# Technical Bulletin

**No:** TCM-0818-A  
ITCM-0818-A

**Product** AOC and MOC (OnCue Models)

**Issue** New Antenna Shield for OnCue Ovens

**ORIGINAL - REMOVABLE (WHITE)**

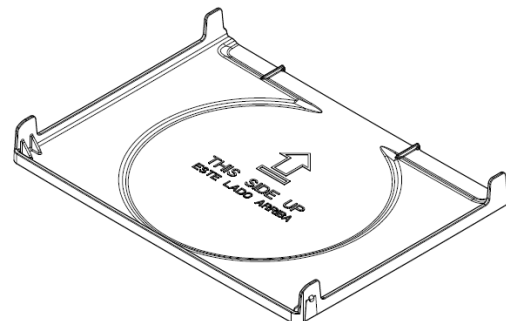
**Action** Effective with serial numbers **1807180146 and later**, OnCue ovens utilize a new, smooth black, permanently installed antenna shield.

**ALL SERVICE PARTS** will substitute to the new style shield Part #59184614.

**Should the shield need to be removed in the future:**

- 1) Use a suction cup (Part #59001235 pictured below).
- 2) Attach the suction cup to the smooth, center section of the shield.
- 3) Press on the rear cavity wall and pull straight down on suction cup.

During installation, **DO NOT** press the center of the shield as antenna damage may occur.
